Planning Commission
CITY HALL COUNCIL CHAMBERS
AGENDA OF JANUARY 14, 2025
7:00 PM

PPZ2024-0319: Development Plan

CITY LIMITS
RESTAURANT & LOUNGE
PATIO & PARKING LOT IMPROVEMENTS
SITUATED IN THE CITY OF NORTH RIDGEVILLE,
COUNTY OF LORAIN, STATE OF OHIO

PROPOSED ADA RAMP SIDE VIEW
SCALE: 1" = 5'

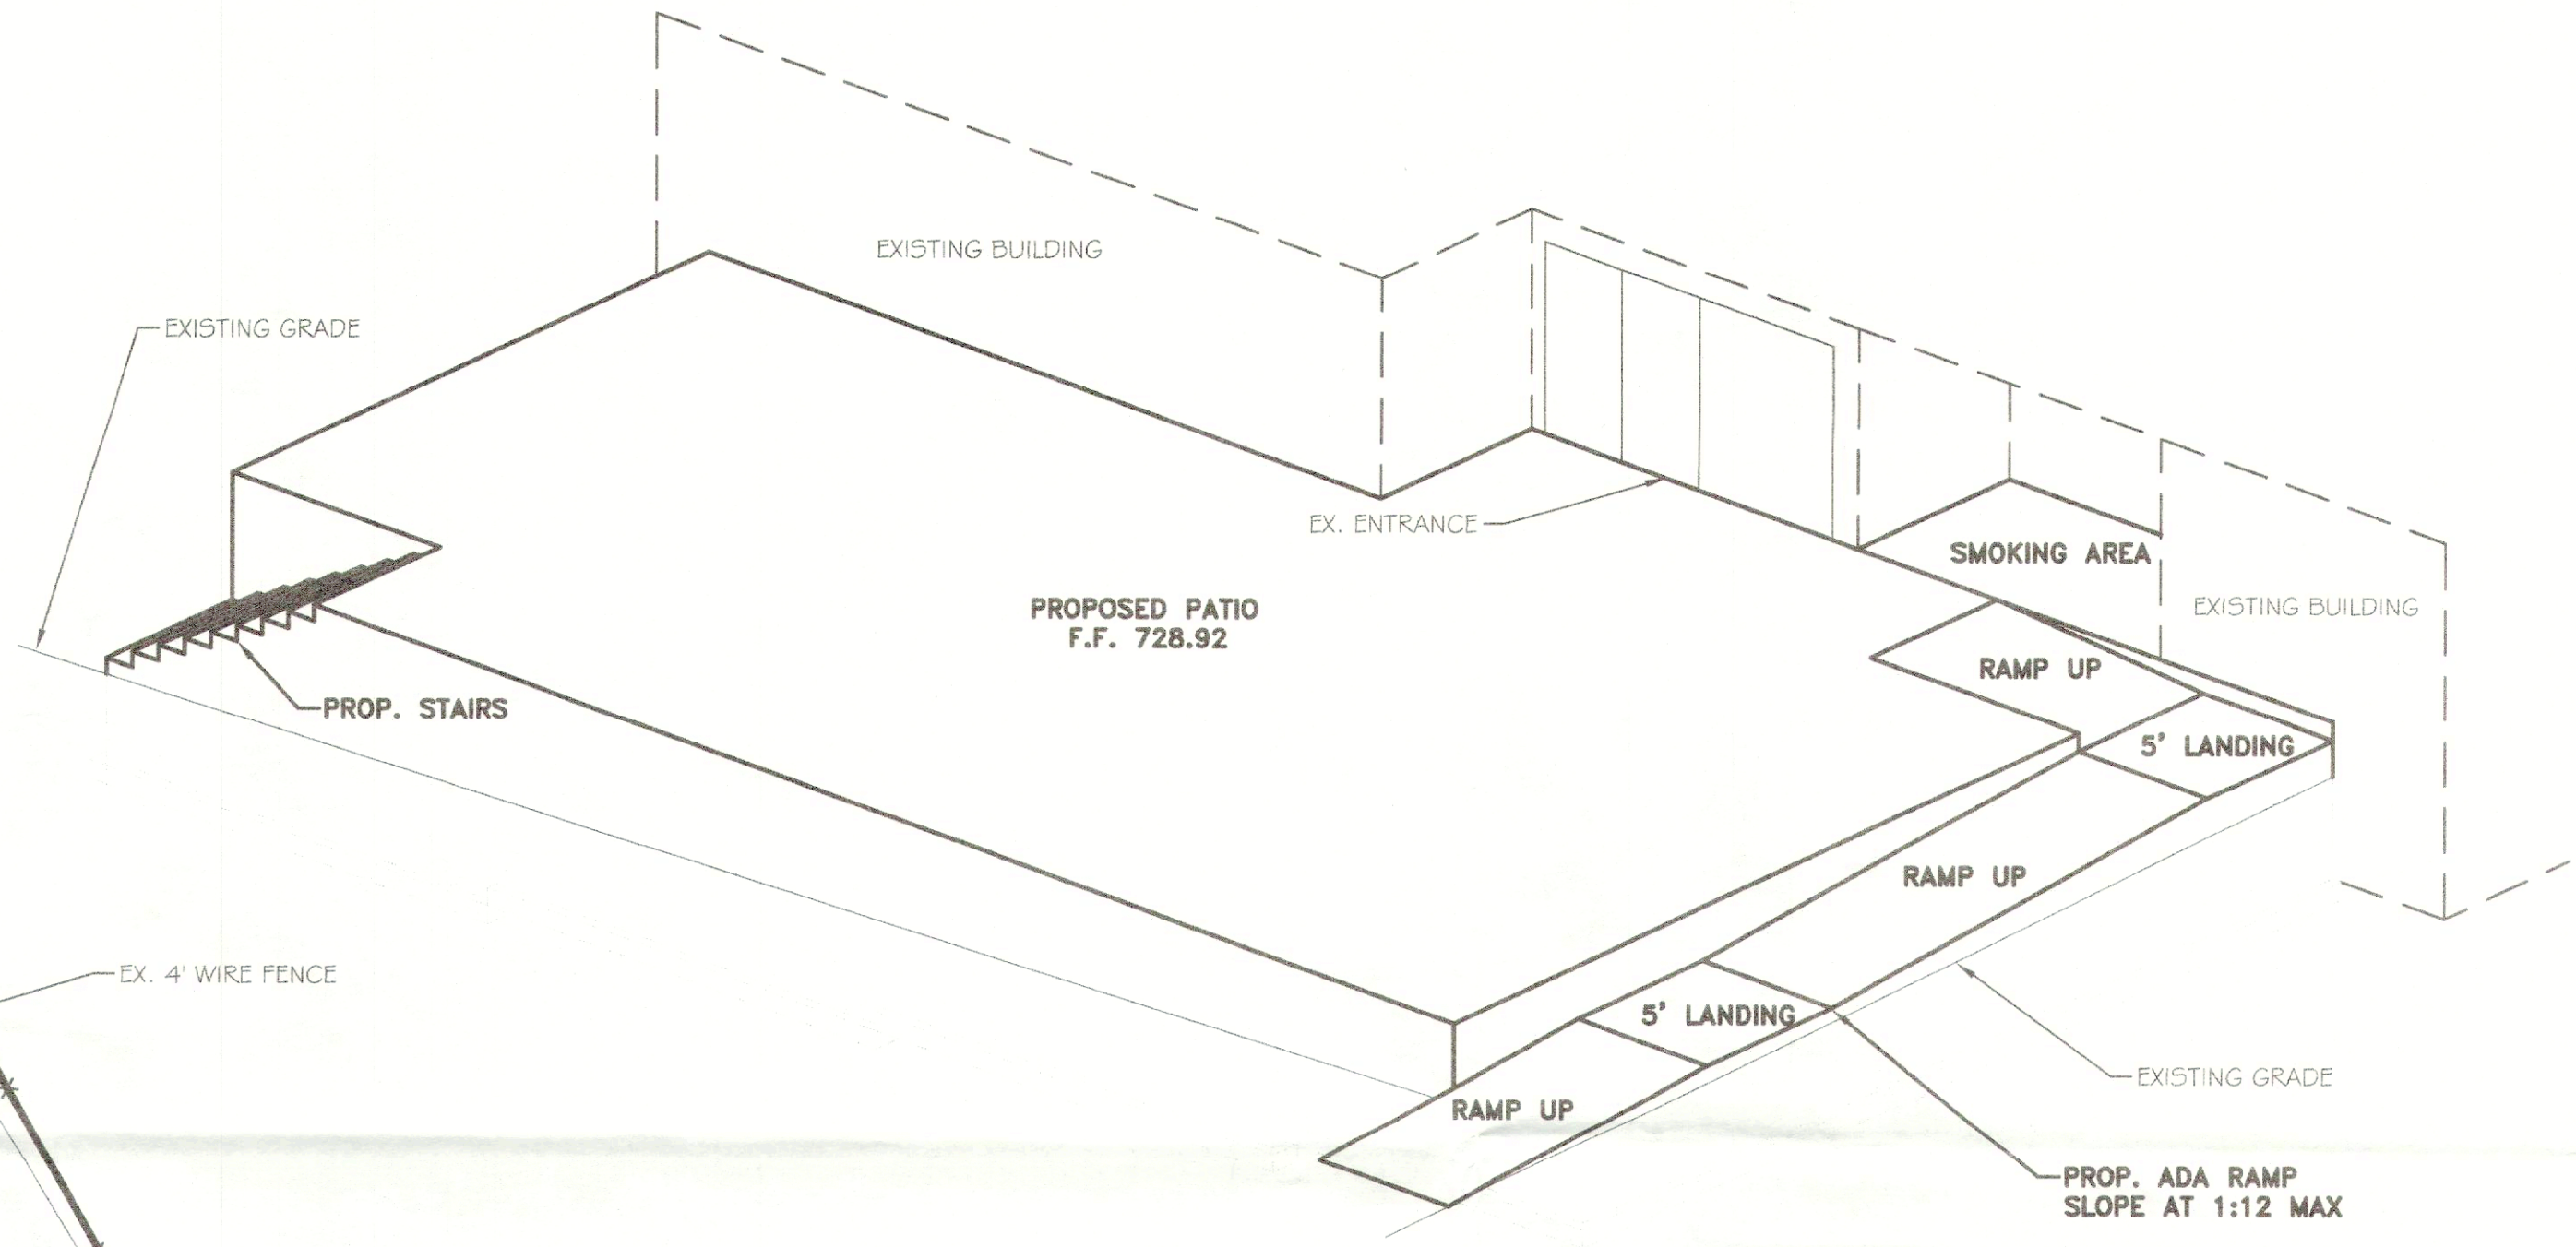
- Christina asked about the patio and if it were raised. Stephen stated that it was raised on one side with 7-inch risers. Christina stated that when they submitted for final engineering, she would like to see a grading plan with some spot elevations. She asked if there was just one entrance into the building. Stephen stated that there was one entrance on the side of the building but there were several throughout the whole building.
